**PLANNING AND ZONING COMMISSION AGENDA**  
**Monday, March 14, 2016**

**STAFF REPORT  
PLANNING AND ZONING COMMISSION**

**STAFF REPORT**  
**KETCHUM PLANNING AND ZONING COMMISSION**  
**REGULAR MEETING OF MARCH 14, 2016**

**STAFF REPORT**  
**KETCHUM PLANNING AND ZONING COMMISSION**  
**REGULAR MEETING OF MARCH 14, 2016**

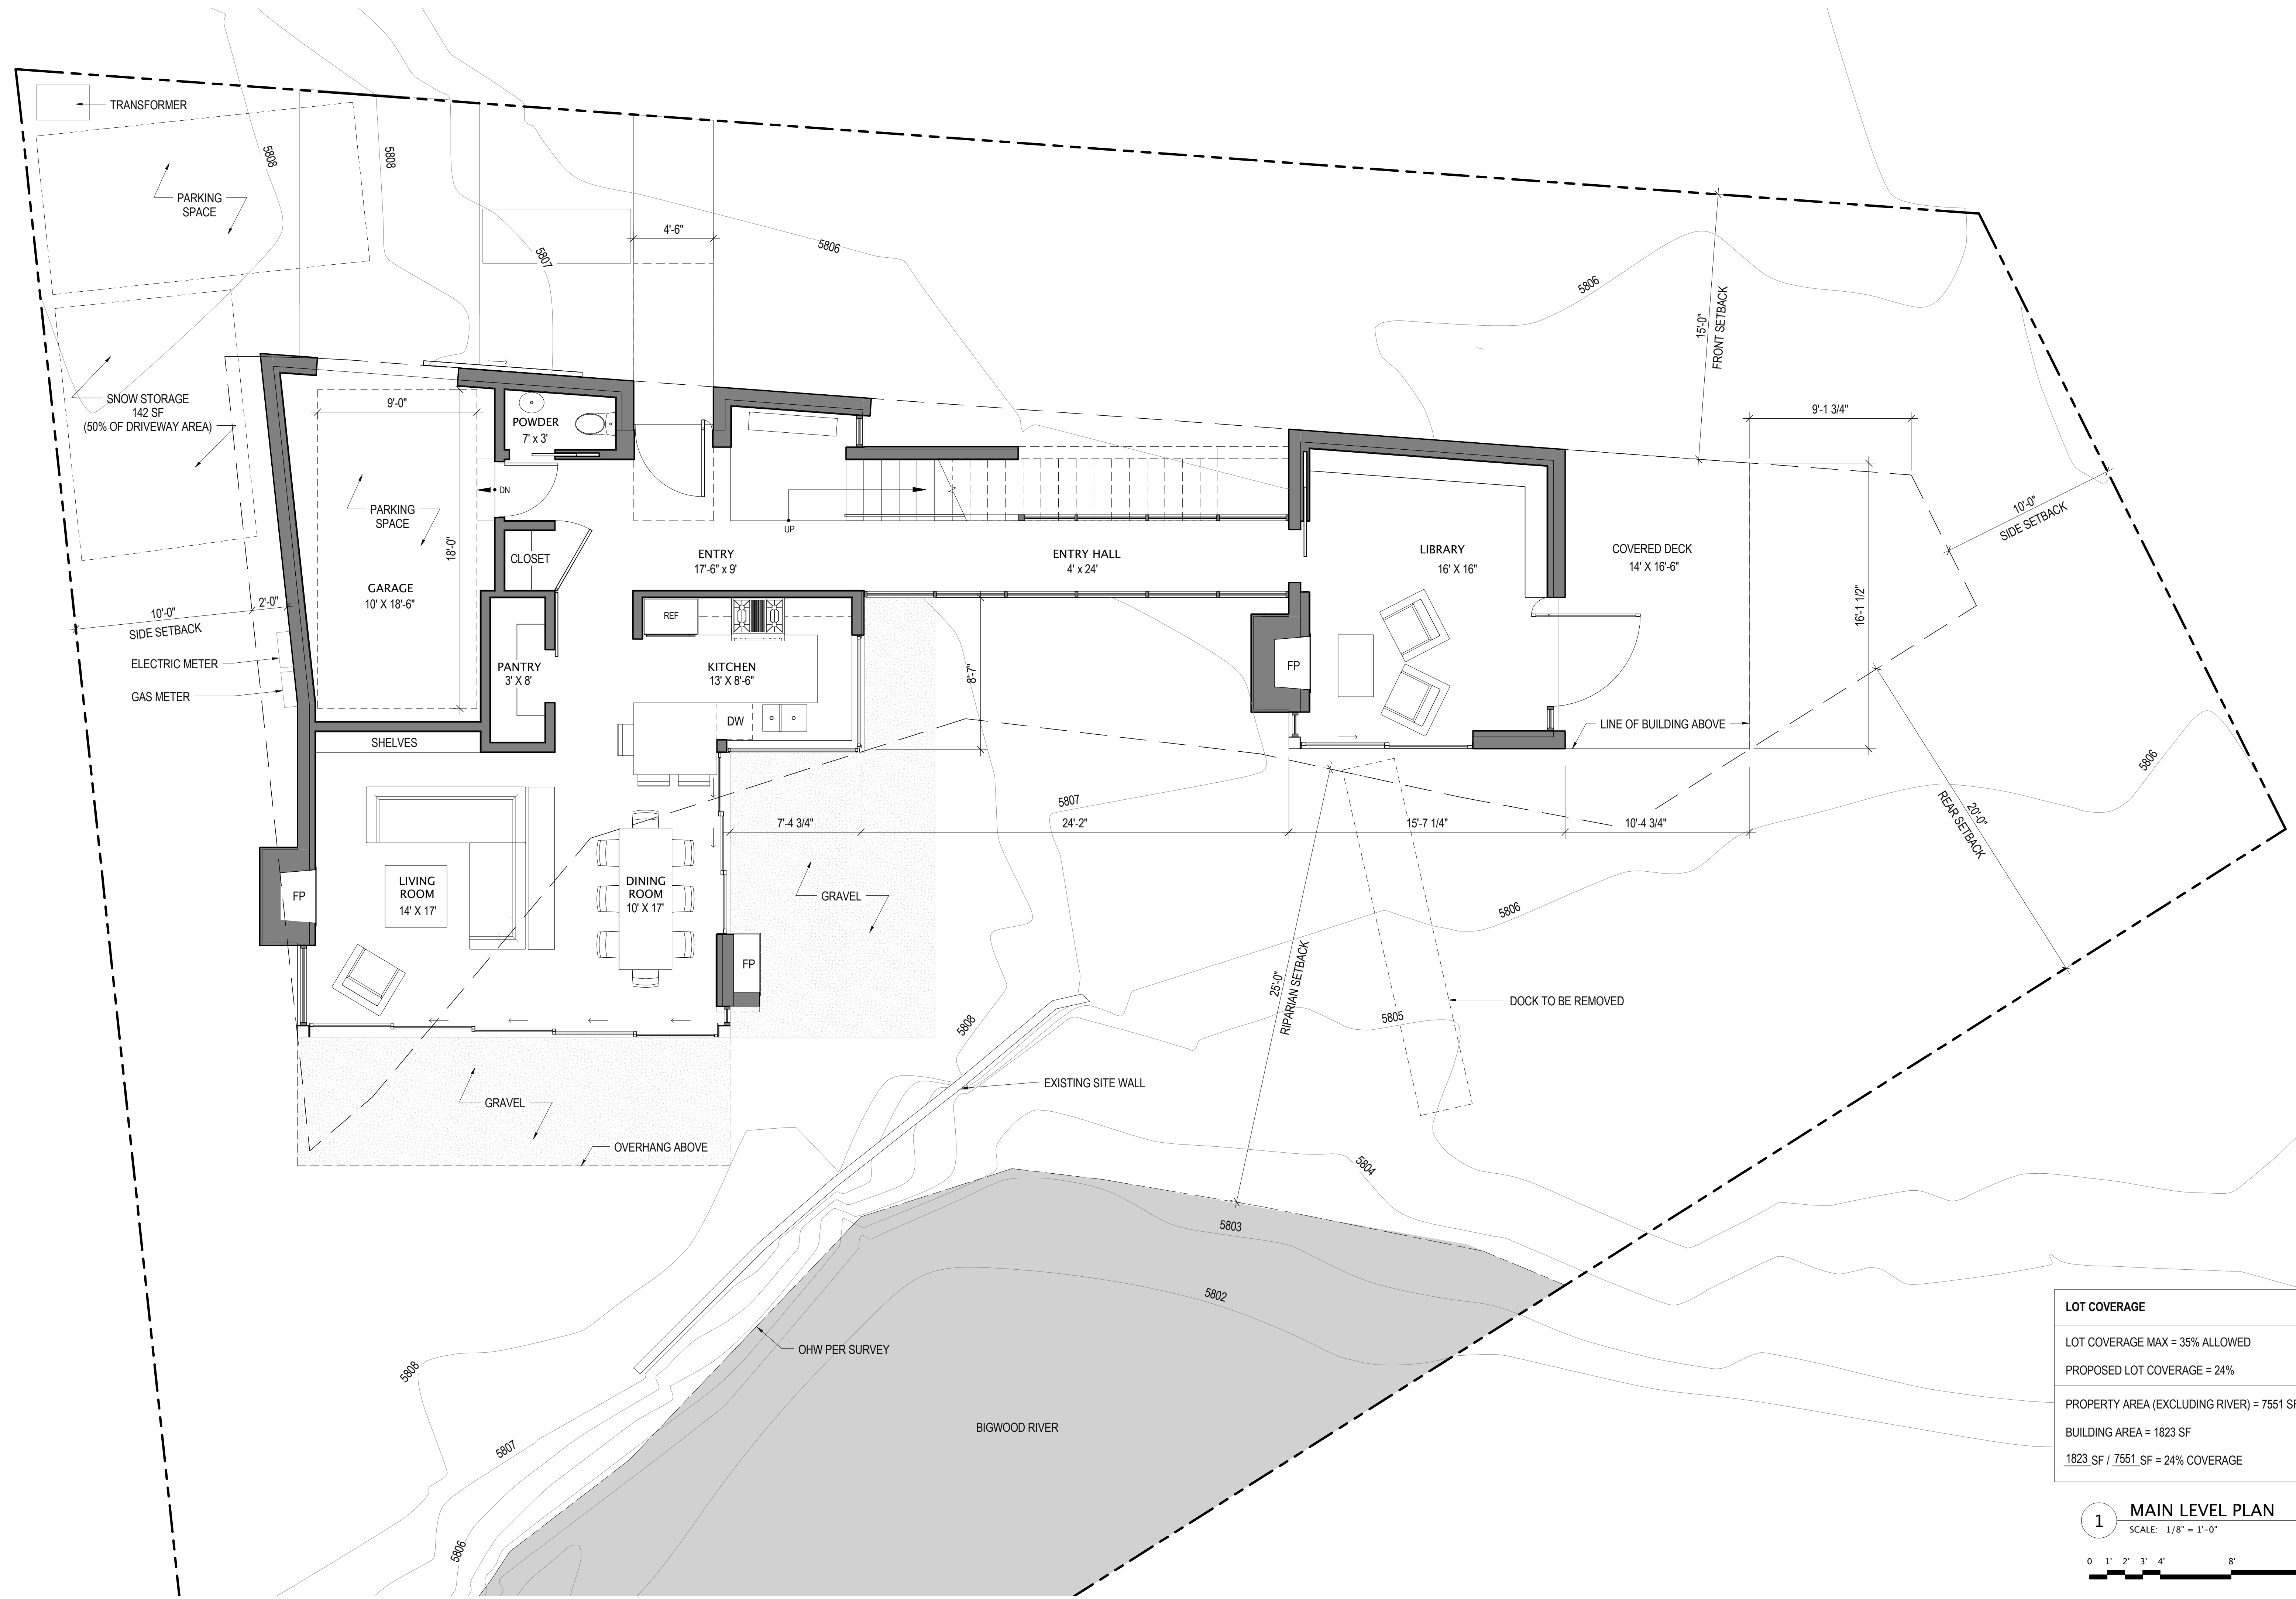
5. The Grading and Drainage Plan shows that the property contains a well on its western edge. Per the Public Works Director’s comments below, the following conditions of approval shall apply:

- Minimum % of slopes detailed in the ROW.
  - Driveway should follow ROW slope and shall not drain into the street.
  - Private property shall not dewater into the ROW, and the project will need to provide drainage in the ROW.

**1 MAIN LEVEL PLAN**  
 SCALE: 1/8" = 1'-0"

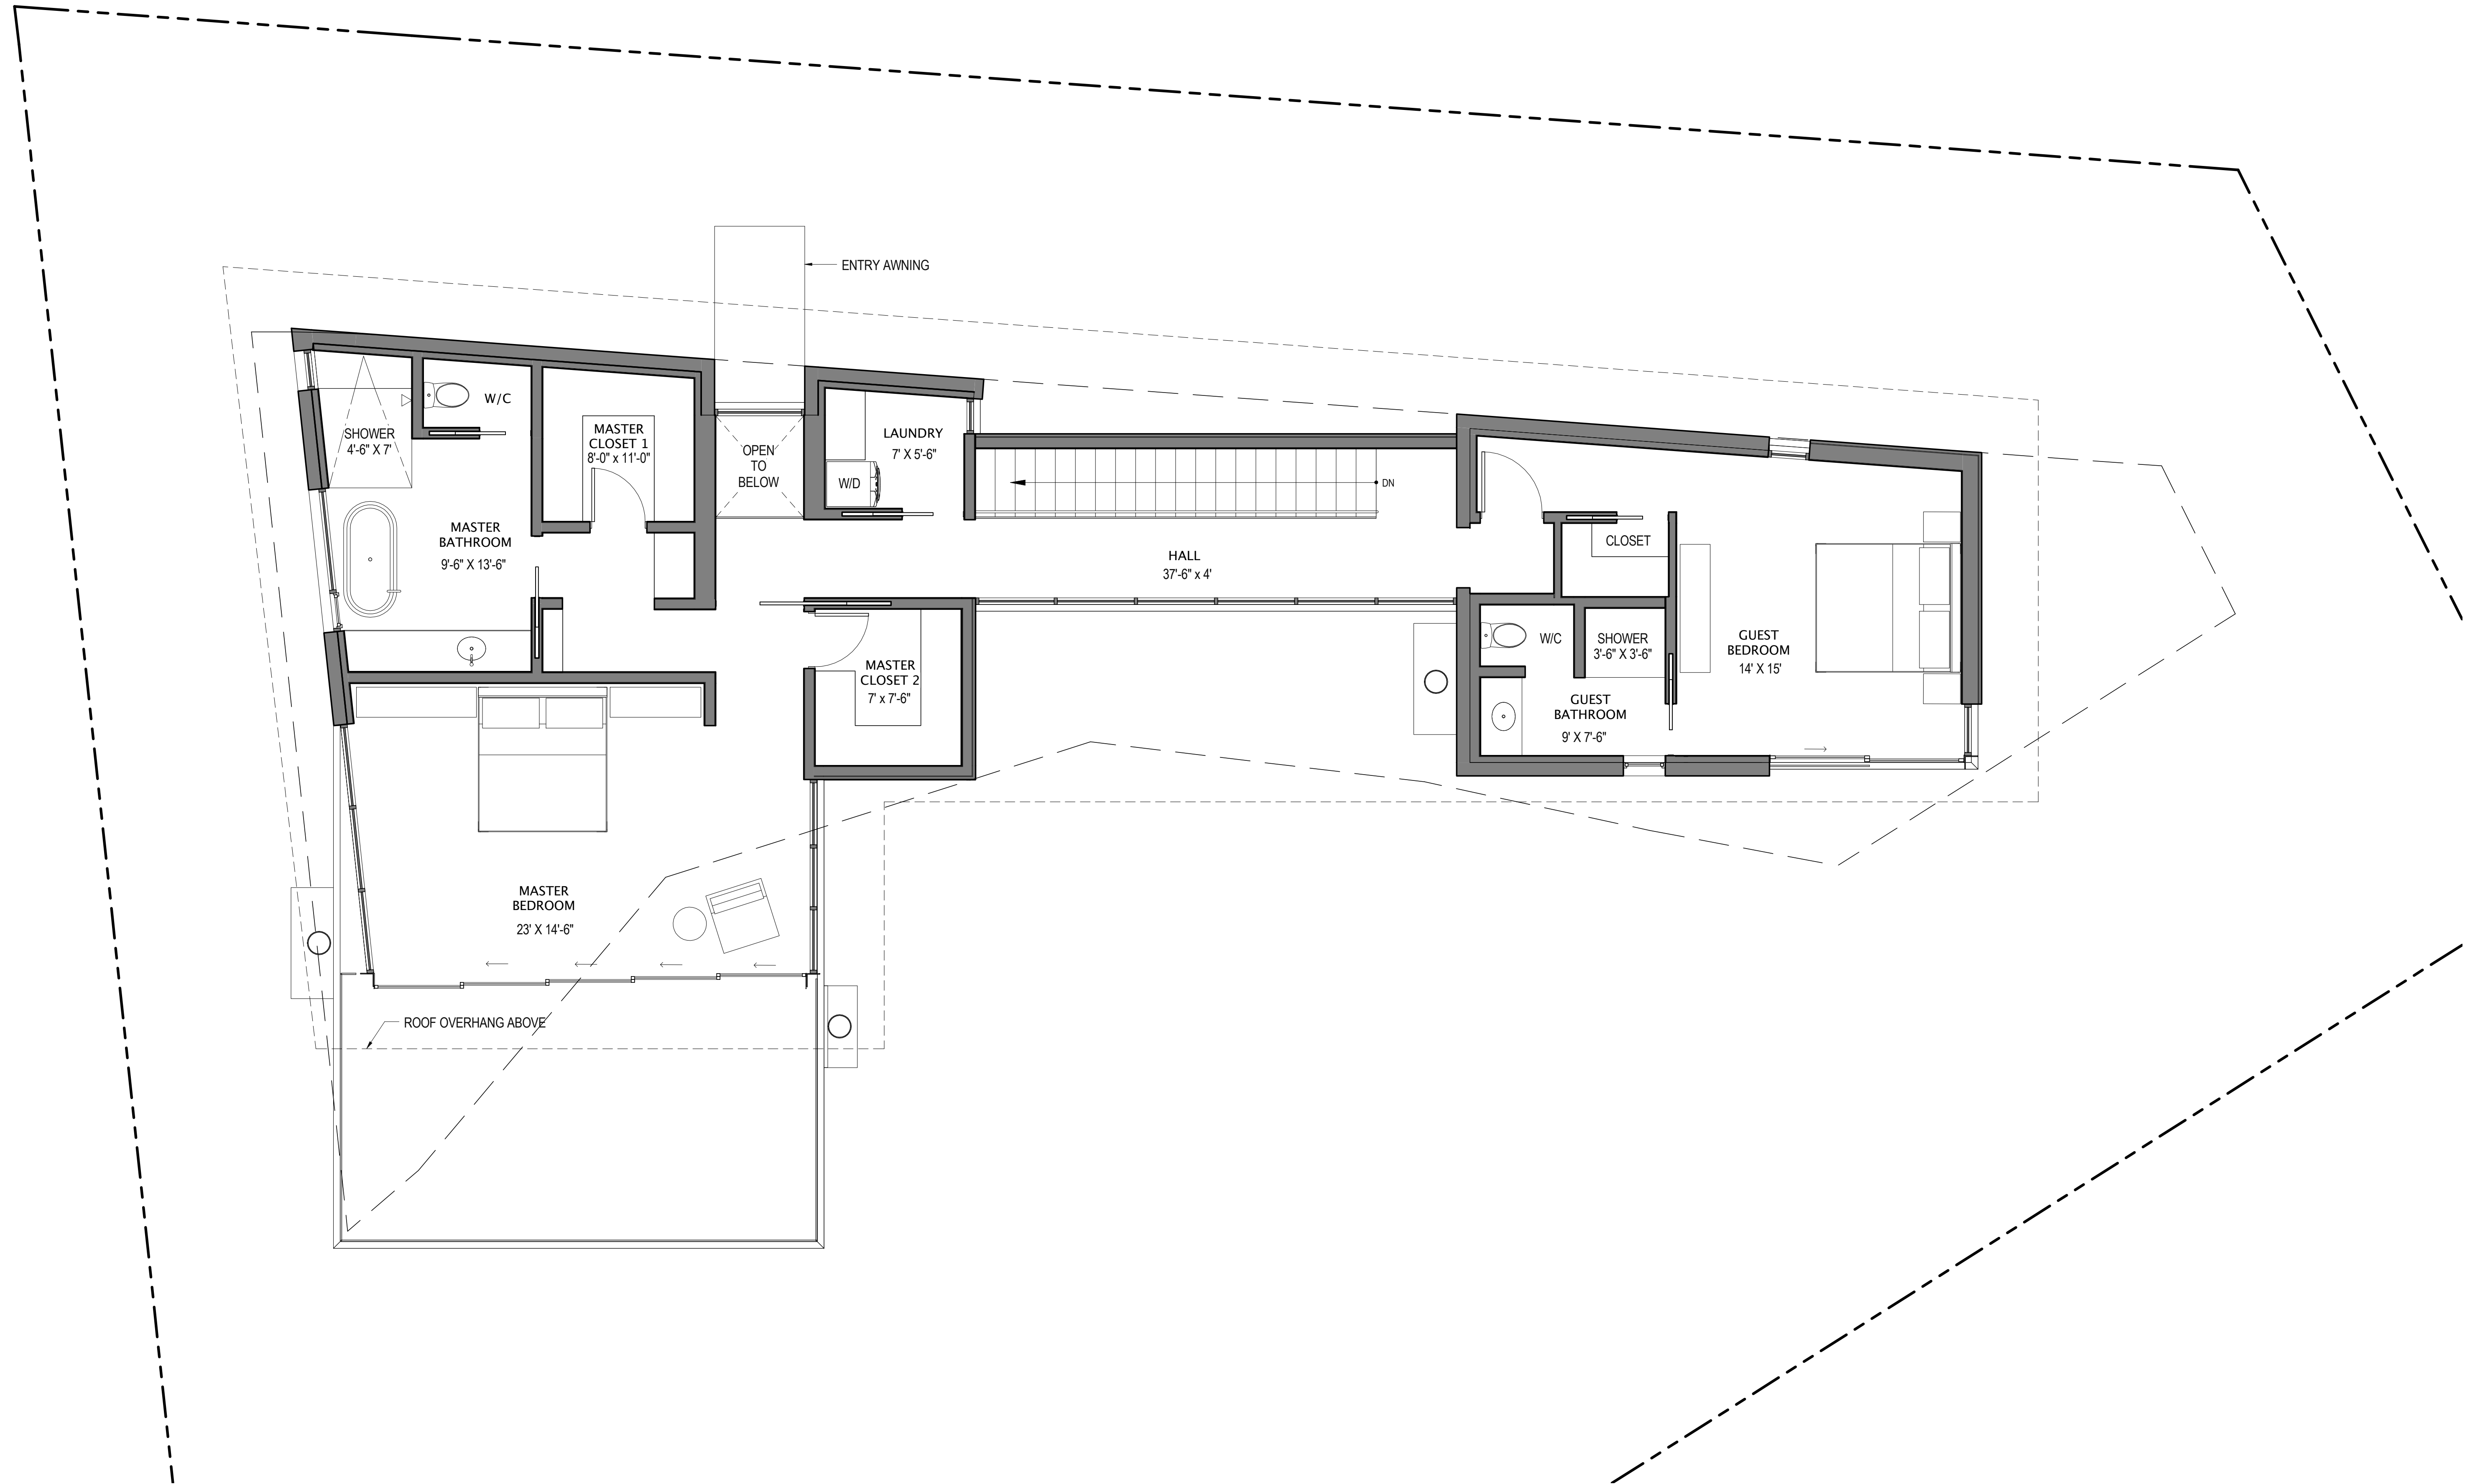
4. The applicant is proposing to remove the southernmost portion of the existing building in the riparian setback and to add the same 715 cubic feet of volume on the second floor level. Staff finds that this improves the degree of encroachment on the ground in the riparian setback and does not increase the degree of nonconformity. In addition, the applicant proposes to demolish the inadequate existing second story deck and to rebuild it higher at the new second story level, again not increasing the degree of nonconformity at ground level.
